Subject: **CAITHNESS BLYTHE II, LLC'S DATA RESPONSES SET 1  
BLYTHE ENERGY PROJECT PHASE II AMENDMENT  
DOCKET NO. (02-AFC-1C)**

# **BLYTHE ENERGY PROJECT PHASE II**

**(02-AFC-1C)**

**DATA RESPONSES SET 1**

Figure 6-1

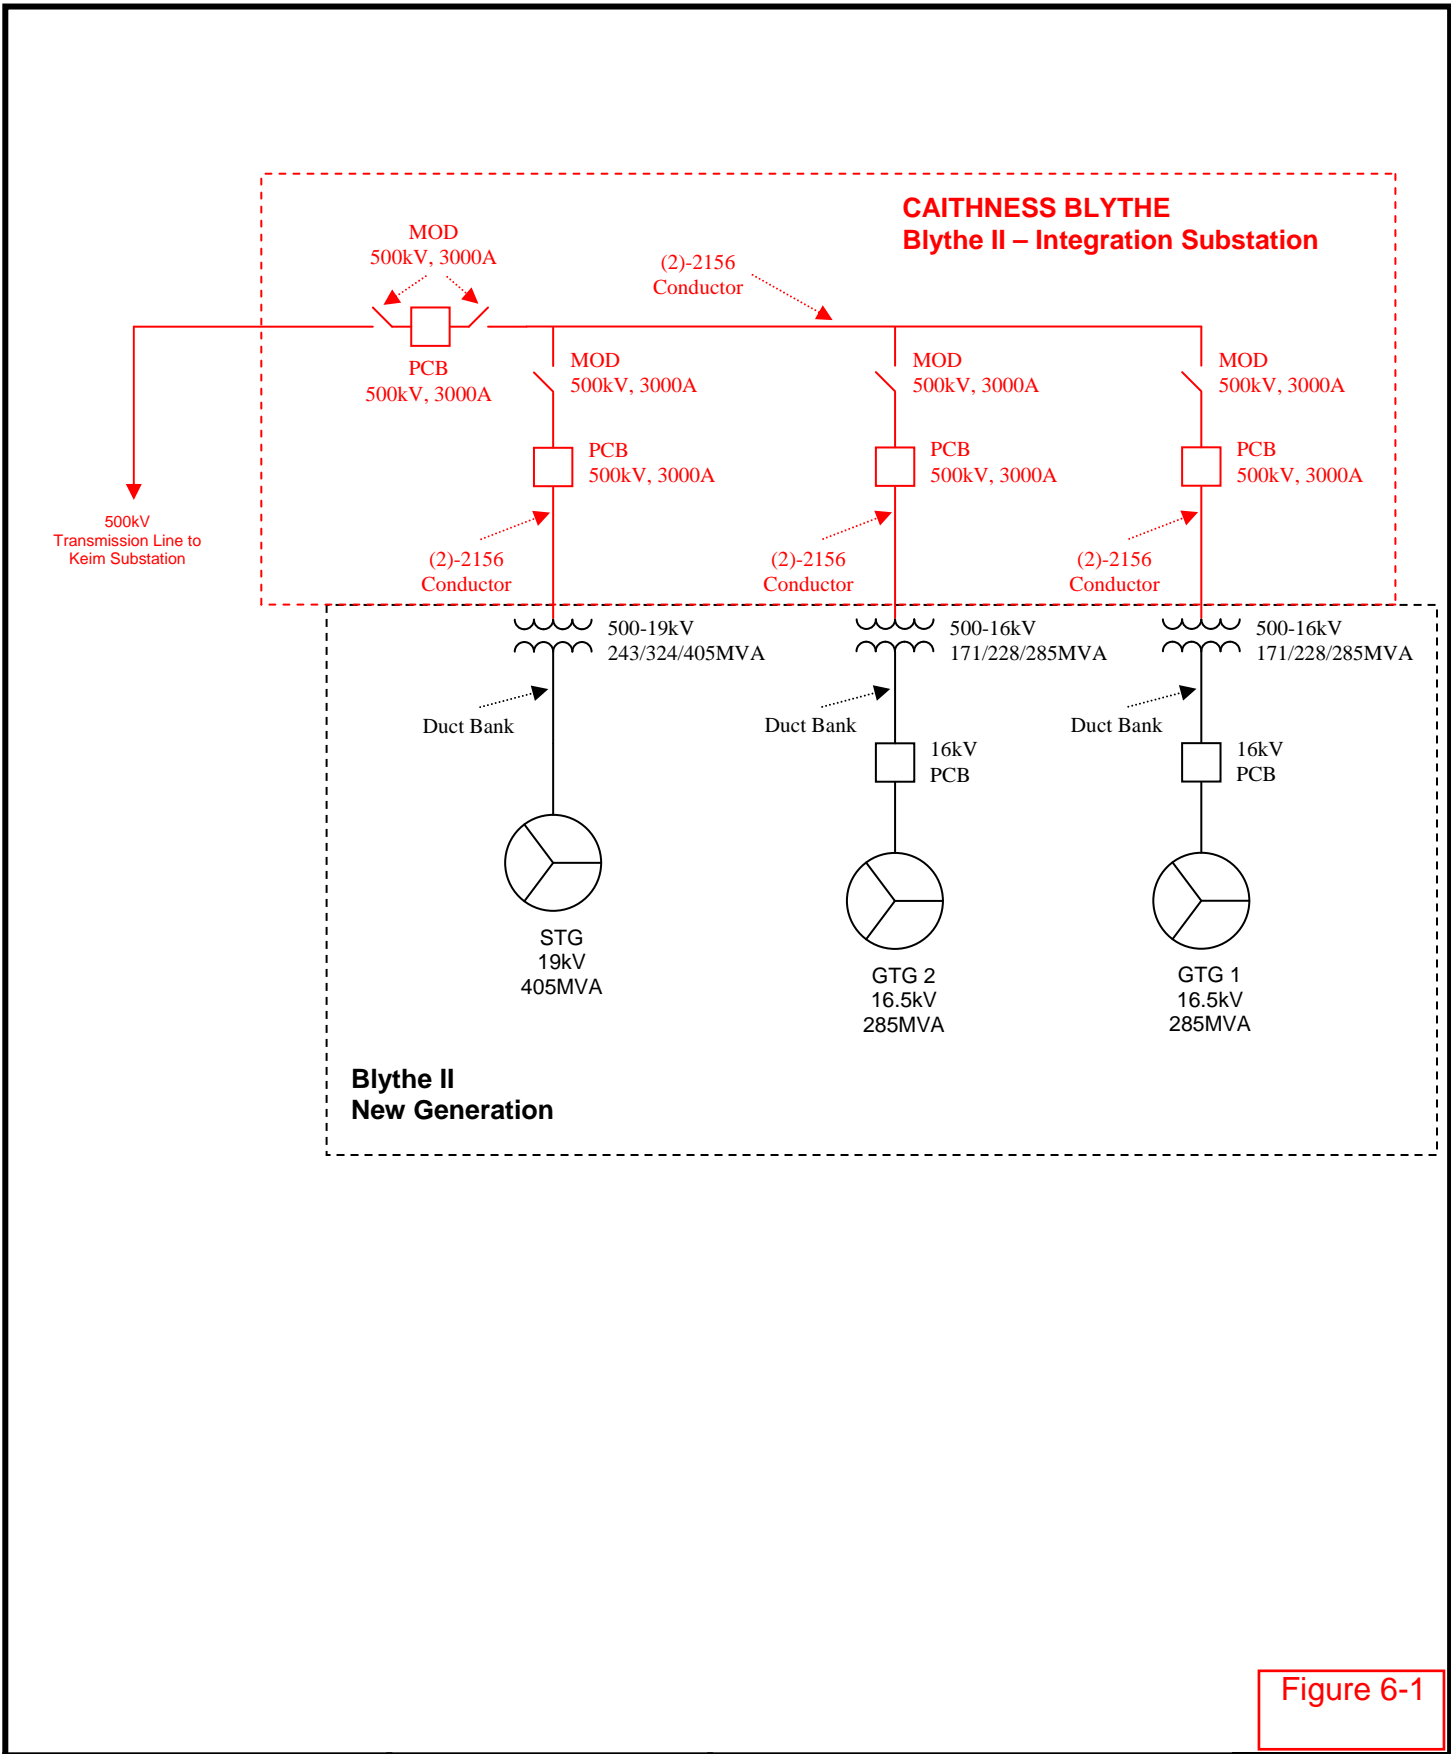
2. Please provide a complete electrical one-line diagram of the BEP II 500kV integration switchyard showing the following:
  - a. The MVA and voltage rating of each new generator
  - b. All major equipment for generators' interconnection to the switchyard including:
    - any buses
    - bus duct connectors and/or cables,
    - breakers & disconnect switches on the 16 kV low side,
    - generator step-up (GSU) transformers (MVA & kV),
    - short overhead conductors or cables,
    - arrangements of buses, breakers, and disconnect switches on the 500 kV side and their respective sizes and/or ratings in amperes.
  - c. The termination facilities for the transmission outlets.

Please see the attached Data Response Set 1 Appendix. Attachment 1 in the Data Response Set 1 Appendix is Figure 6-1, an electrical one-line diagram of the BEP II 500kV integration switchyard.

**FIGURE 6-2**

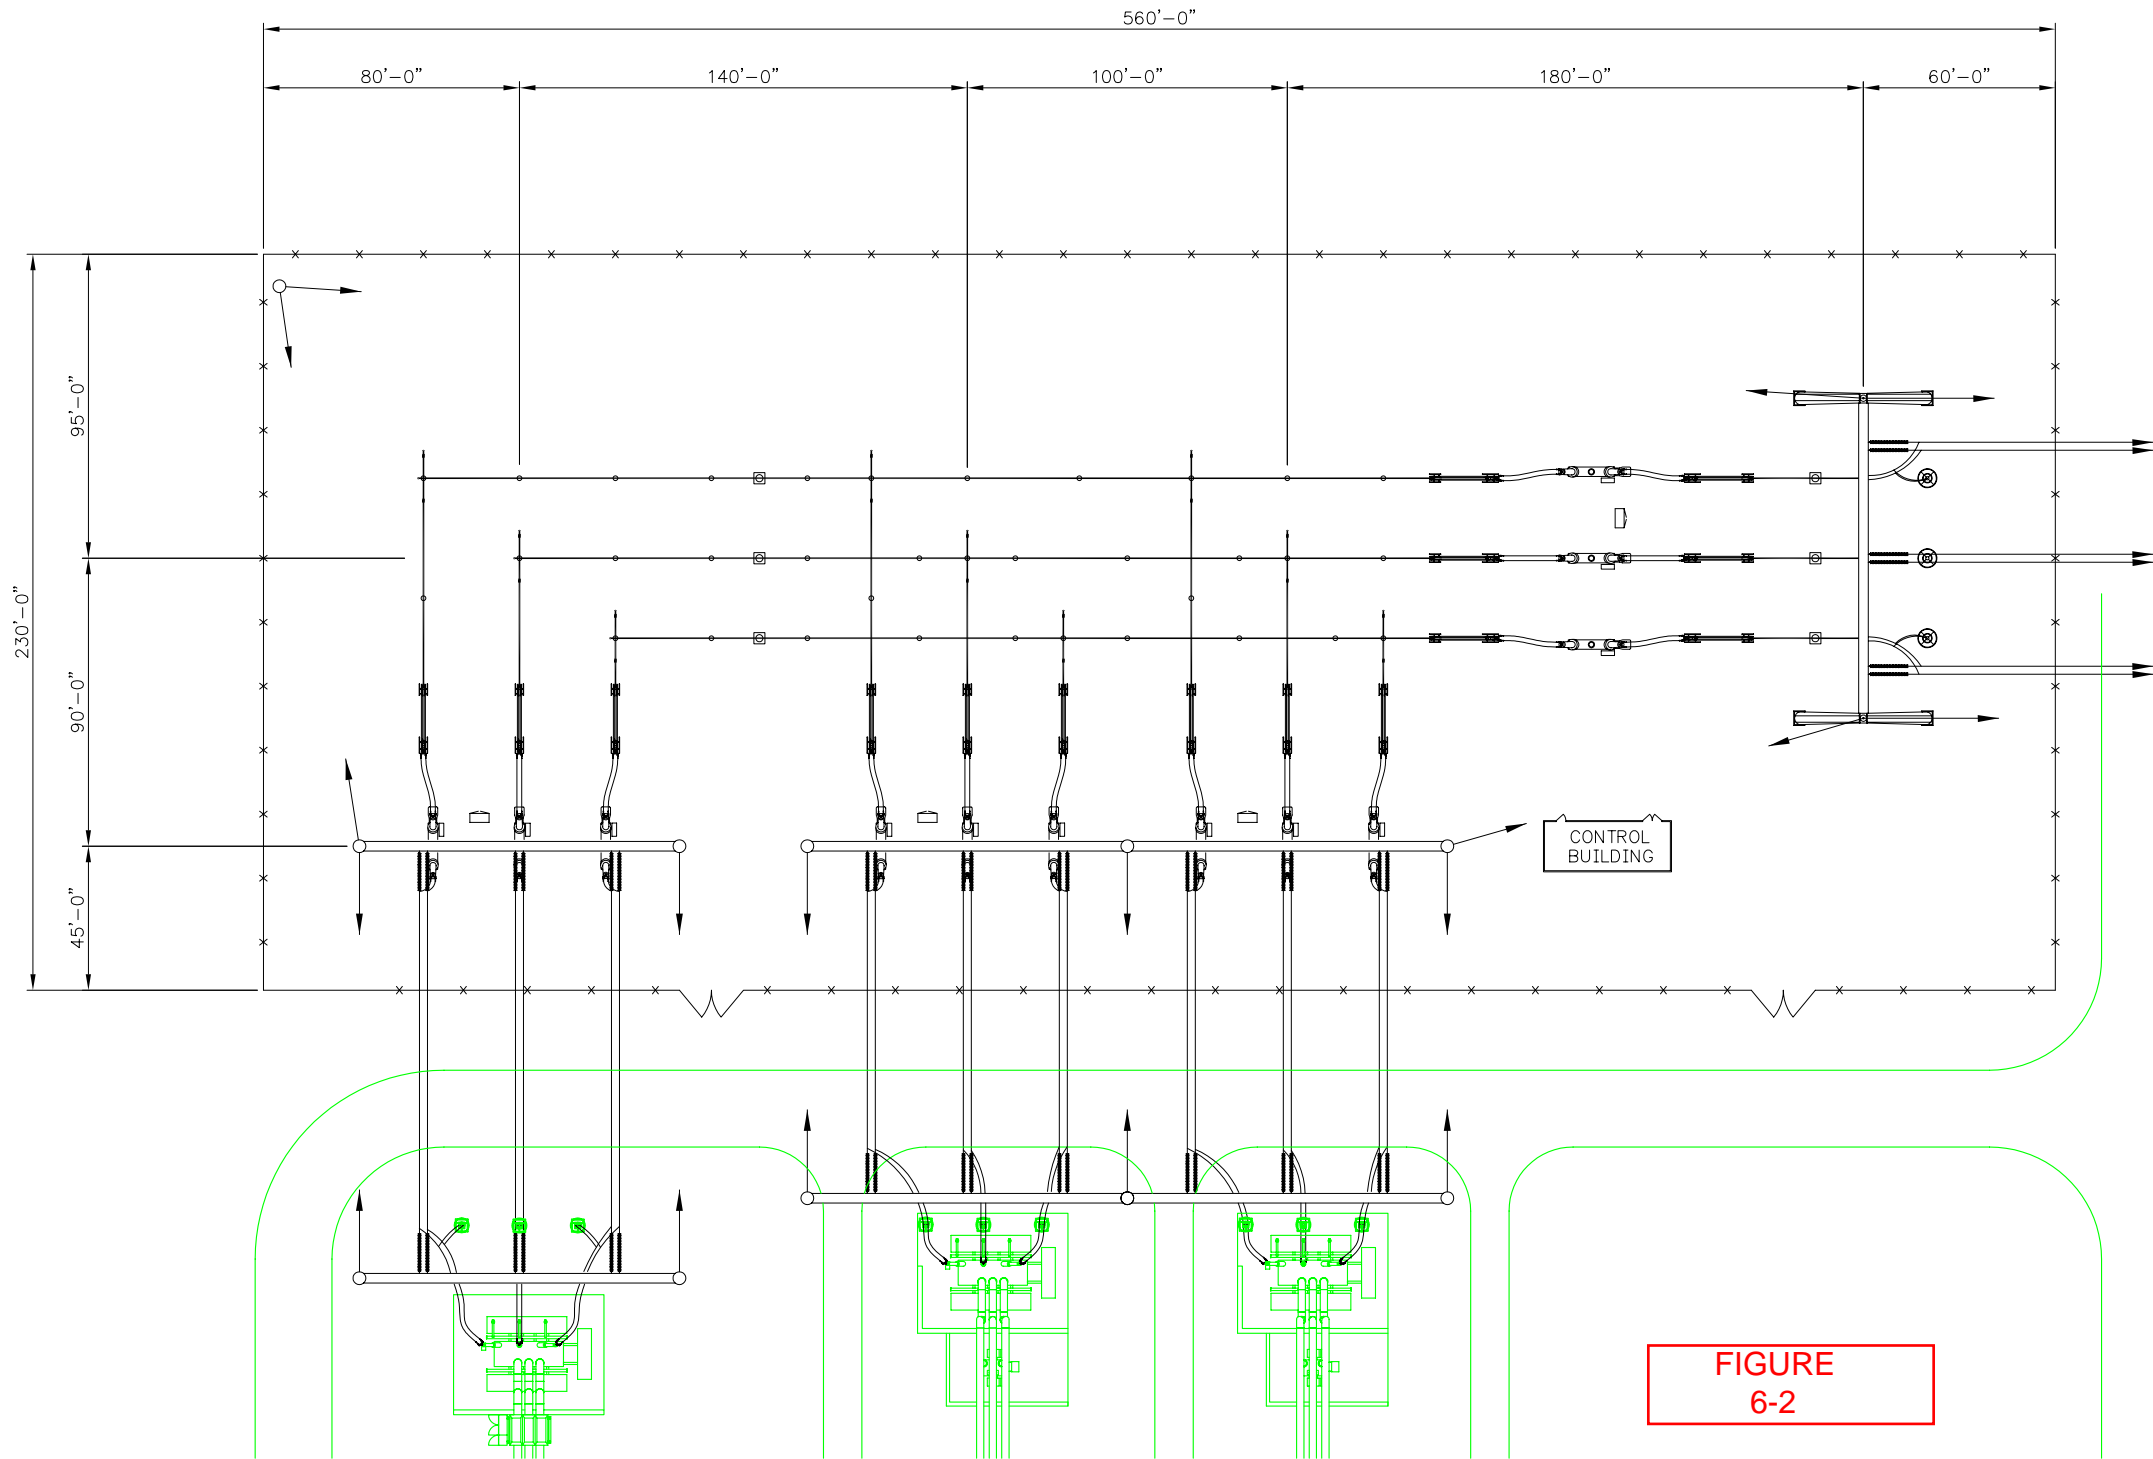
3. Please provide a complete physical layout drawing of the proposed switchyard showing major equipment and transmission line outlets.

Please see the attached Data Response Set 1 Appendix. Attachment 2 in the Data Response Set 1 Appendix is Figure 6-2, a complete physical layout of the proposed switchyard.

Figure 6-3

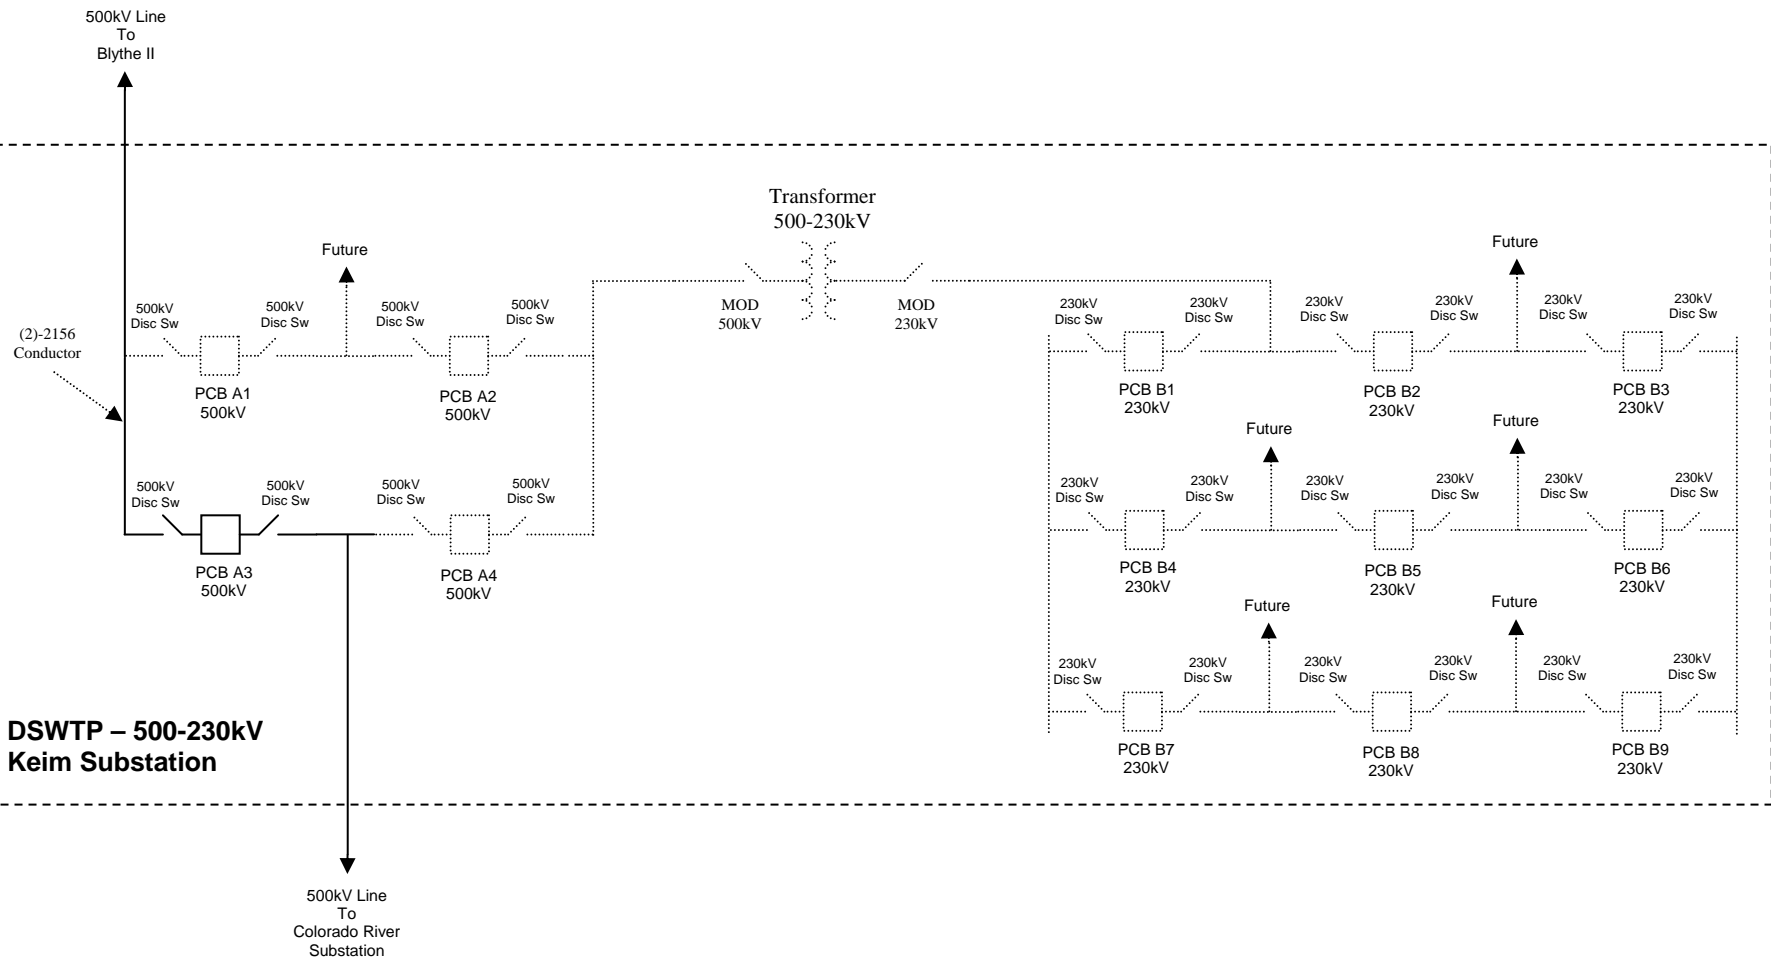
- 5. Please provide a complete electrical one-line diagram of the proposed new Keim 500 kV substation showing arrangements of buses, breakers, disconnect switches and their respective sizes and/or ratings in amperes along with the termination facilities of the proposed transmission outlets.**

Please see the attached Data Response Set 1 Appendix. Attachment 5 in the Data Response Set 1 Appendix is Figure 6-3, an electrical one-line diagram of the permitted Keim 500 kV substation.

**FIGURE**  
**6-4**

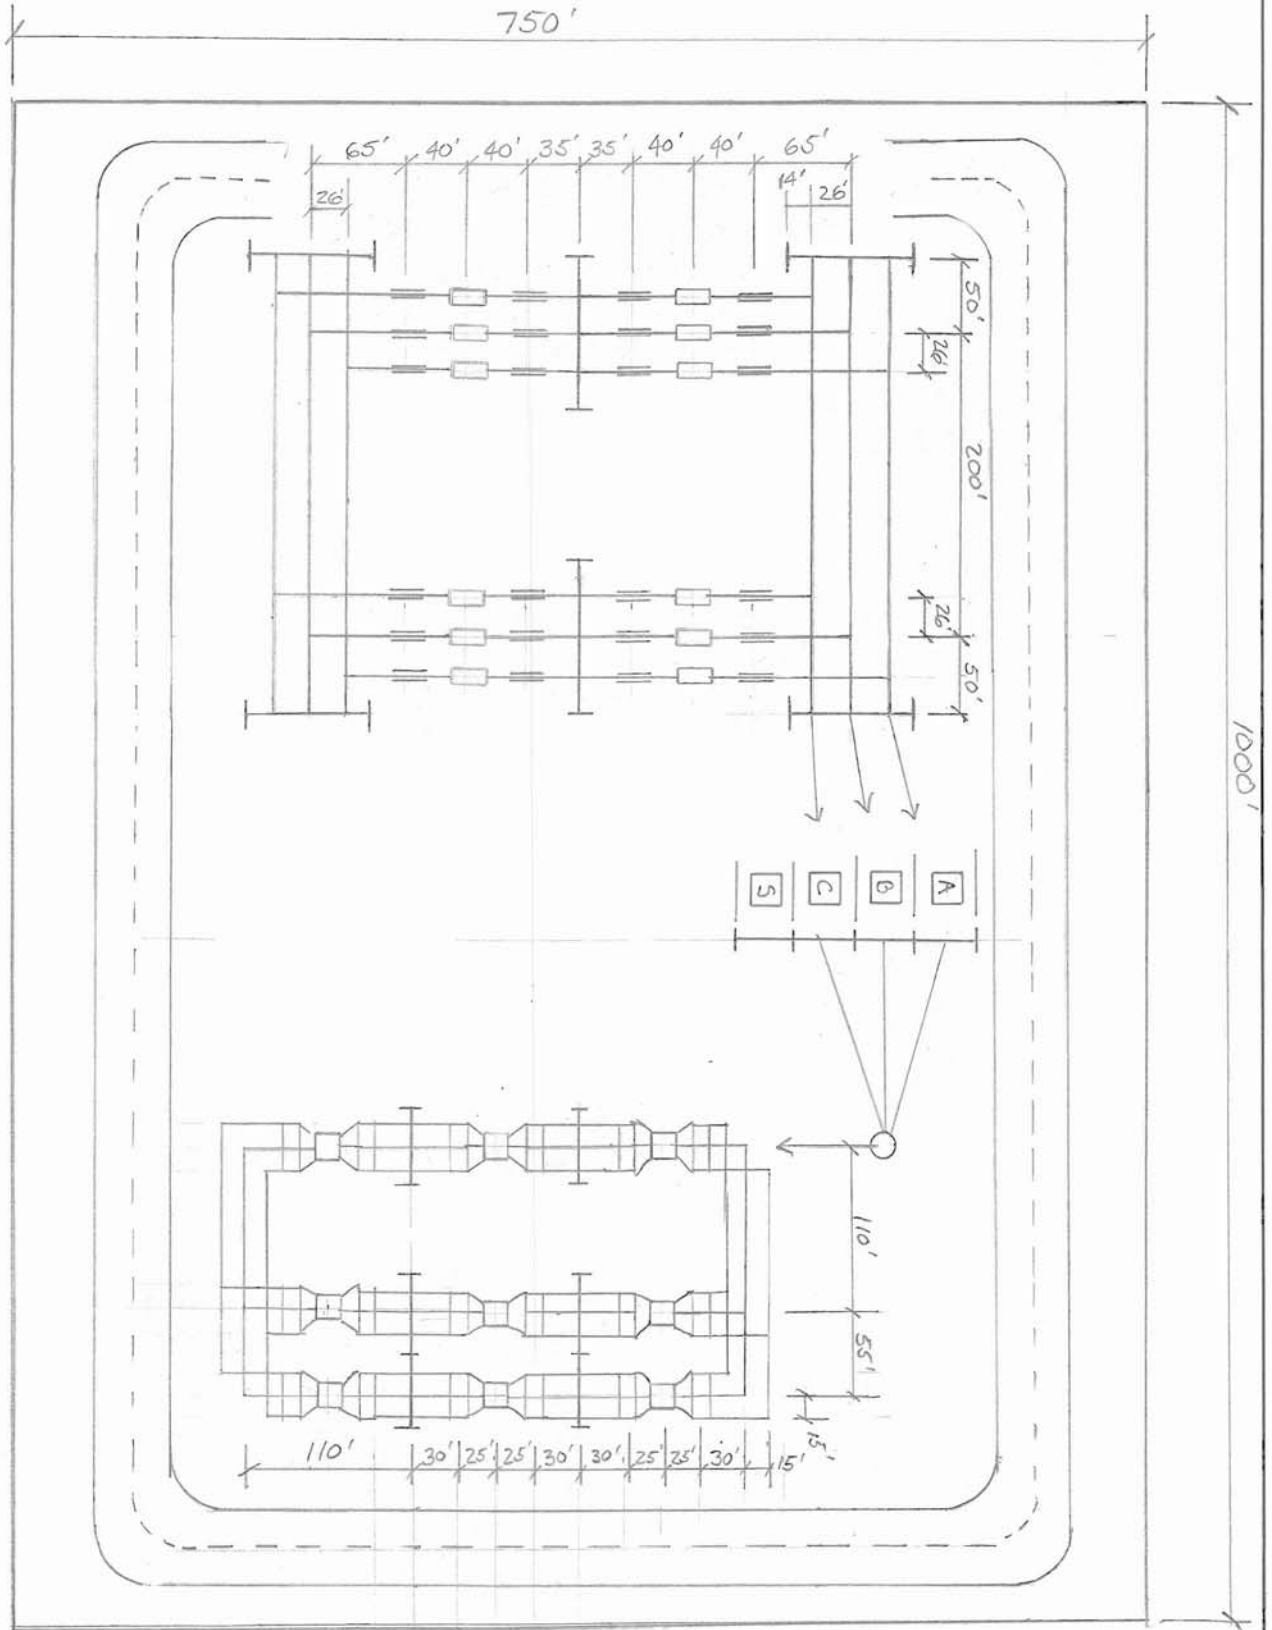
- 6. Please provide a complete physical layout drawing of the proposed Keim substation showing major equipment and transmission line outlets.**

Please see the attached Data Response Set 1 Appendix. Attachment 6 in the Data Response Set 1 Appendix is Figure 6-4, a complete physical layout drawing of the permitted Keim substation.
